Fw: RFQ (Vibrant technik)

Subject: FW: RFQ (Vibrant technik)

COTTAL 265 MM

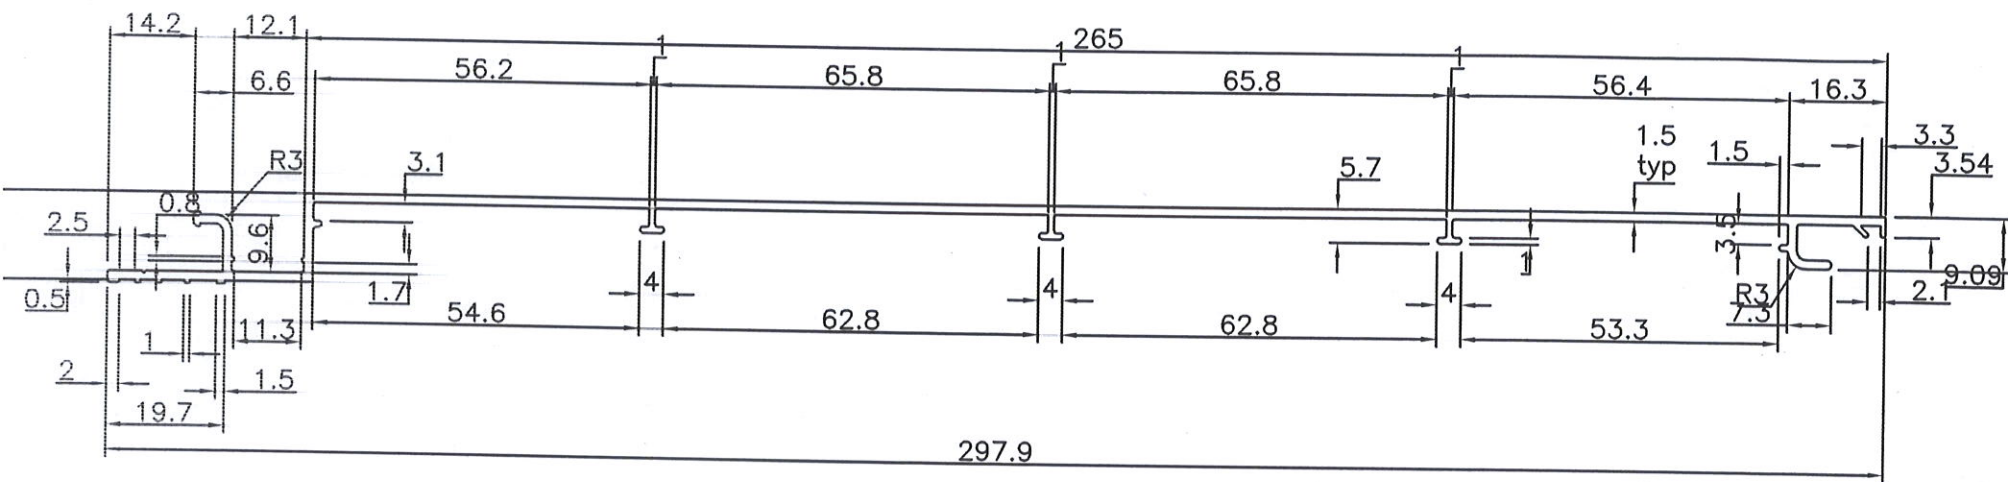
Customer required dimension of the profile 265MM & thickness 1.8mm.

For 265mm width.
we can consider 1.80mm.
wall thickness but we
may face some issues

* 100% manual correction
required due to less
thickness

* dimension's tolerances
will be EN-755-9.

* may be uneven flat
ness.
